Addendum #2

Project: Cumberland County Courthouse Courtroom 12 Acoustic Improvements

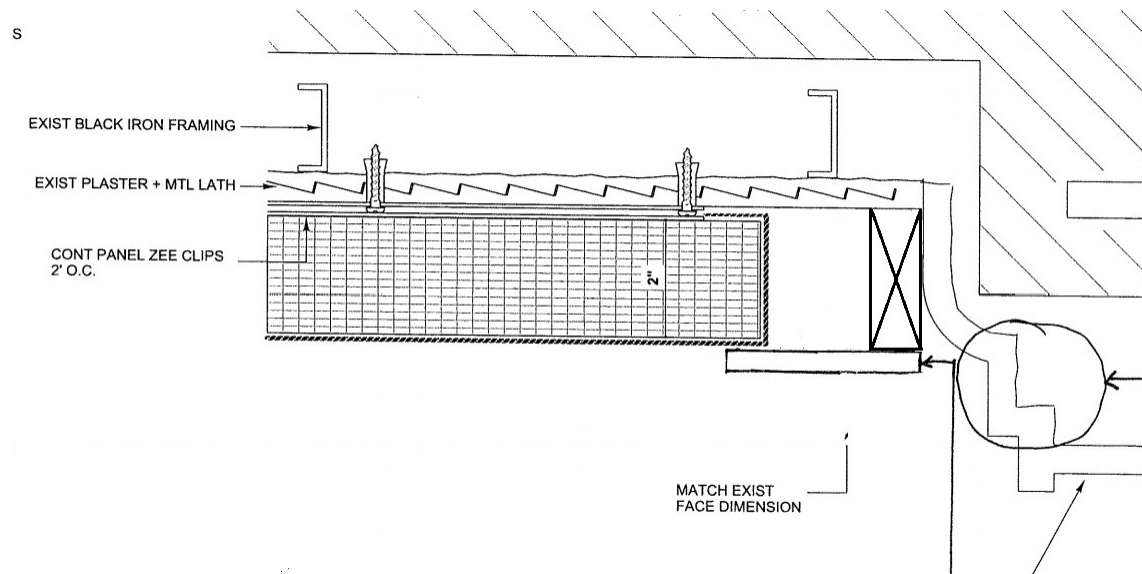
The following drawing will replace the existing trim detail on the ceiling panels.

Existing blocking will need to be modified to be able to accommodate manufacturers recommendation for 1" of space necessary for the panels to slide into the clips. An extra 1/2" of space allows for some fluctuation in the panel width.
